CLA Engineers, Inc.

April 17, 2025

RE: Site Plan Application 25SITE2 Review
145 Route 32 & 18 Powerhouse Road ("Madison Place")
CLA-7873G

SK1

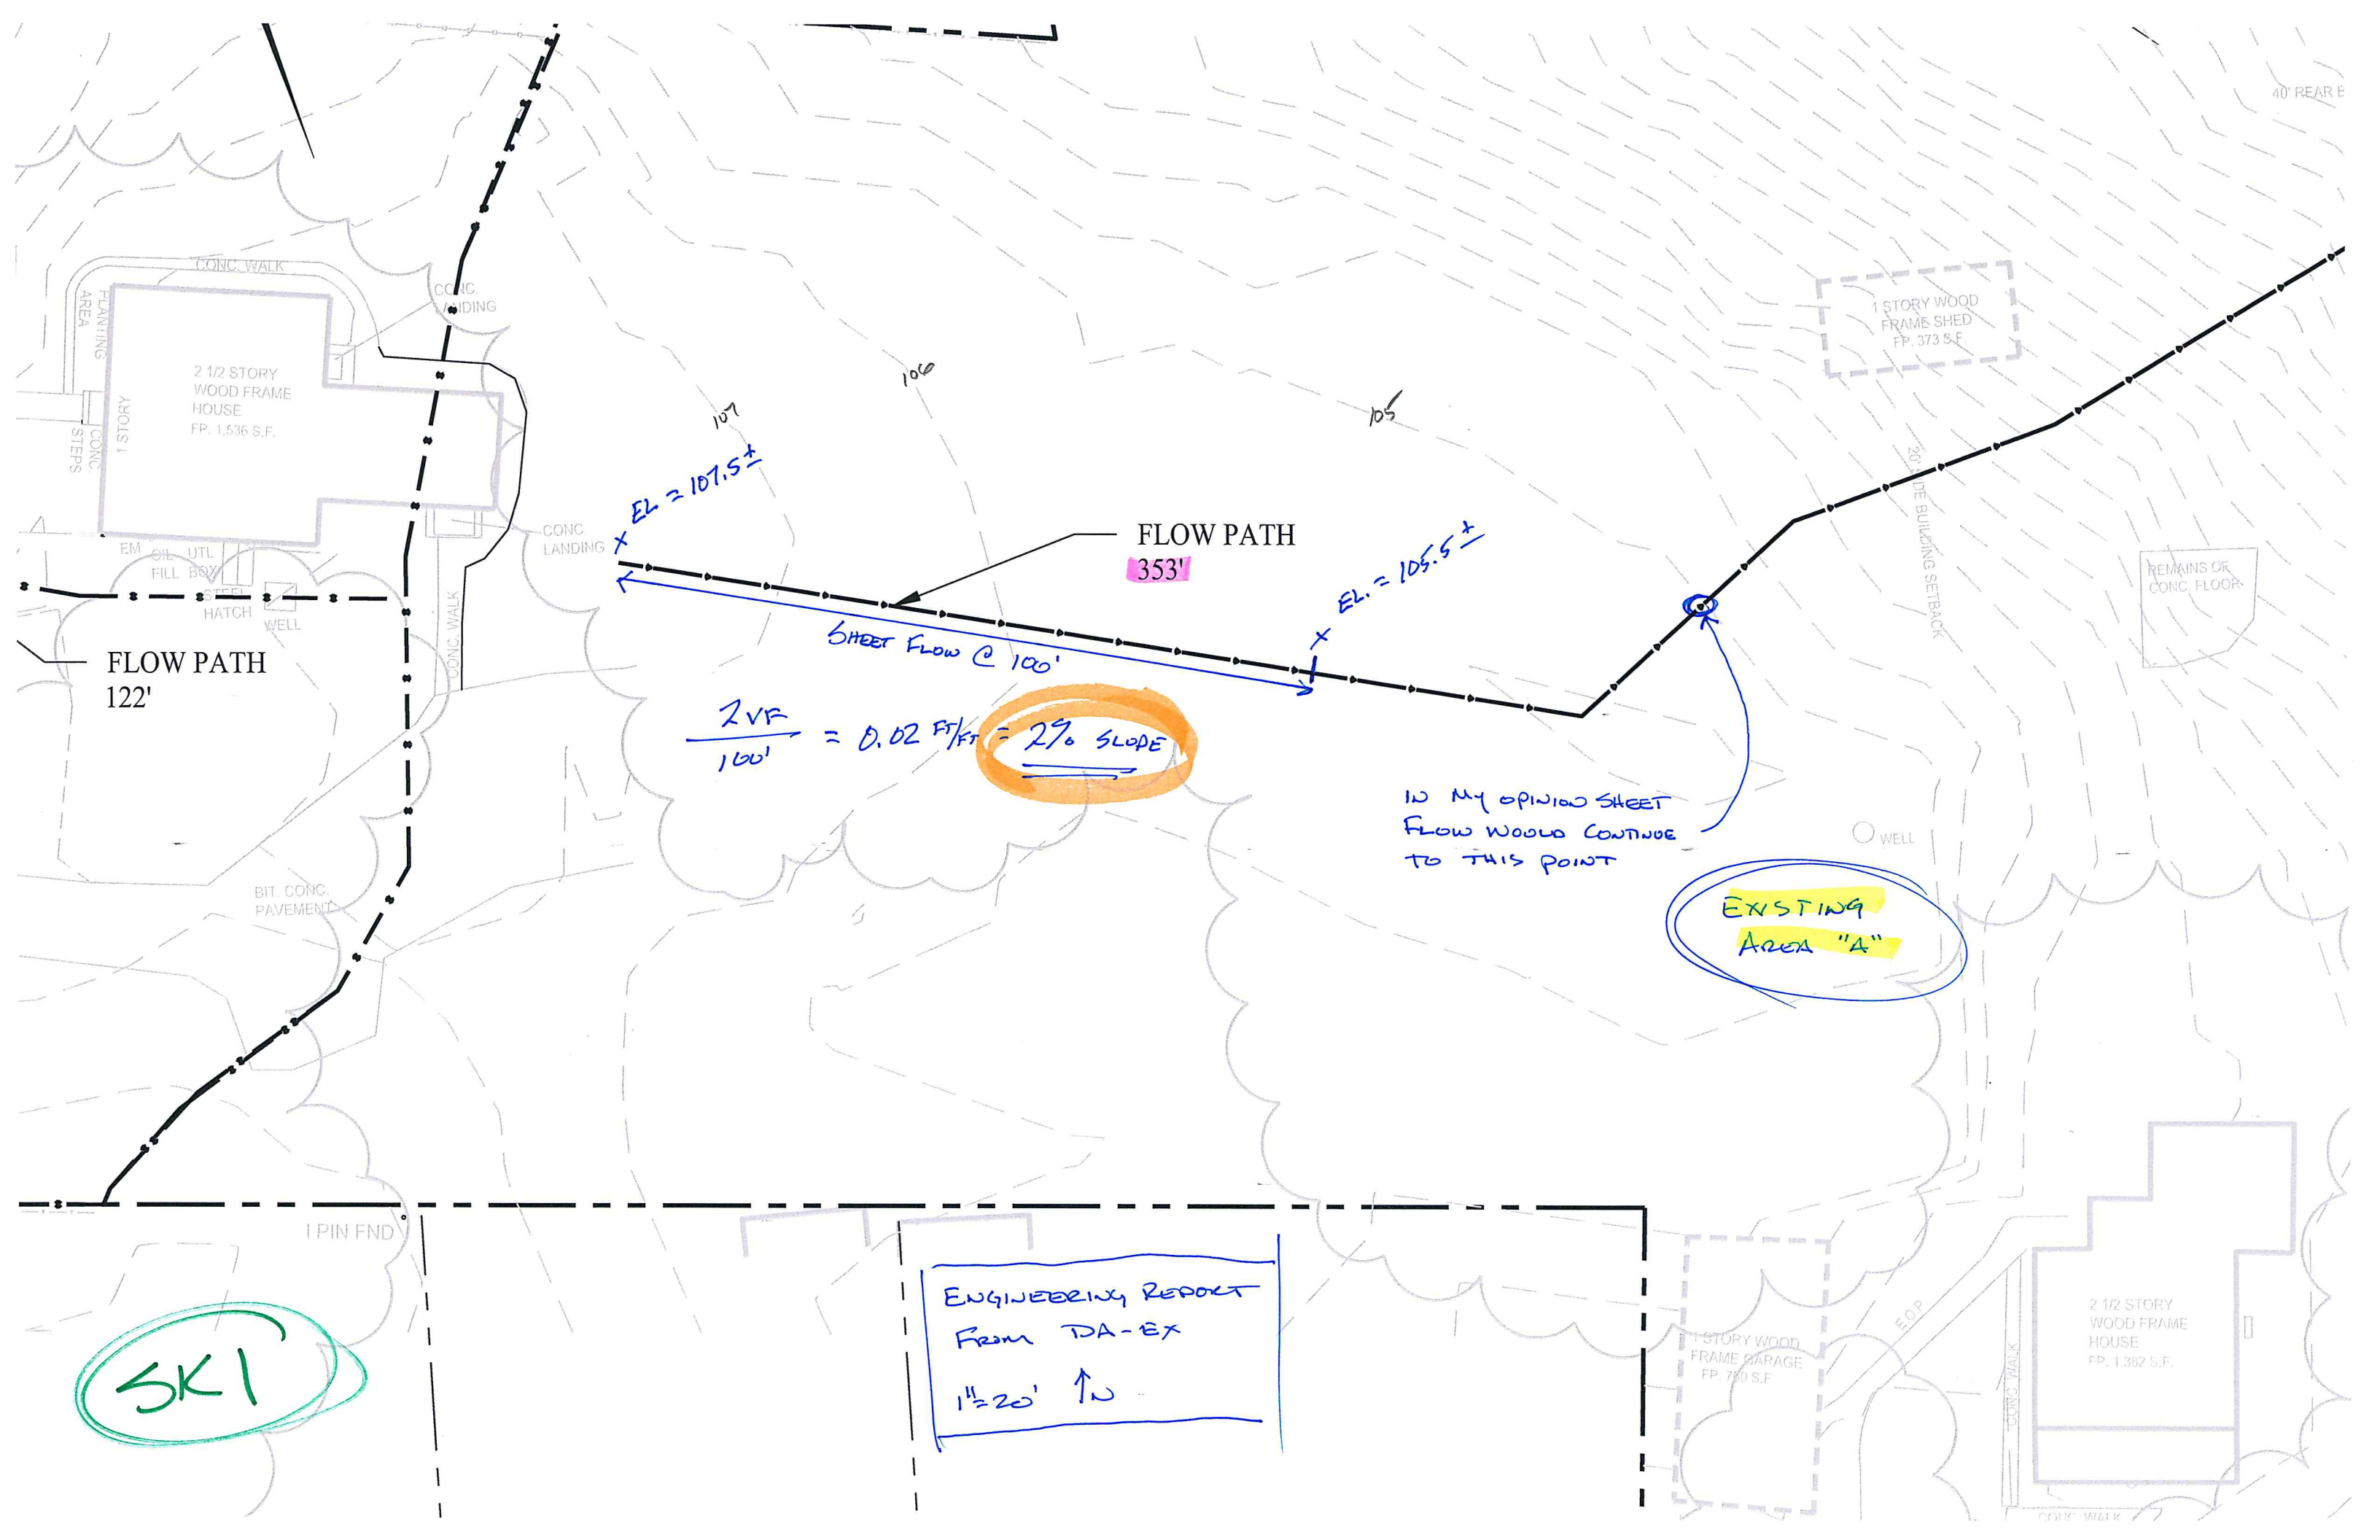
- **In our opinion the sheet flow length for this watershed travel path is longer than the 100' used in the calculations. Please see attached SK1 an excerpt of the DA-EX watershed map from the Engineering Report. In our opinion the sheet flow component would extend to the top of slope at approximately contour 105, adding another ± 60 to the sheet flow component. Limiting this length to 150' would not be unreasonable in accordance with the DOT Drainage Manual Section 6.C.4 (attached).**

- **An aggregate slope should not be used for the entire travel path time of concentration calculation. The actual slope of the land for each segment of the travel path should be used. In this case, sheet flow is the largest component of the time of concentration, and the actual land slope is approximately 2% vs the 8.8% used in the calculations. Using the actual land slope may substantially change the calculations.**

- **Please see the comment above regarding using the actual land slope for each segment when calculating travel times.**
- **Please see attached SK1 and SK2, excerpts from DA-EX and DA-PR indicating two different flow path length for the travel flow path. These differences are not reflected in the calculations (See highlighted summaries attached).**
- **As shown on SK1 and SK2 there appears to be a substantial difference in ground slope for each of the sheet flow components. As previously noted, in this case the sheet flow is the largest component in the time of concentration calculation, and land slope will have impact to those calculations.**

IN MY OPINION SHEET
FLOW WOULD CONTINUE
TO THIS POINT
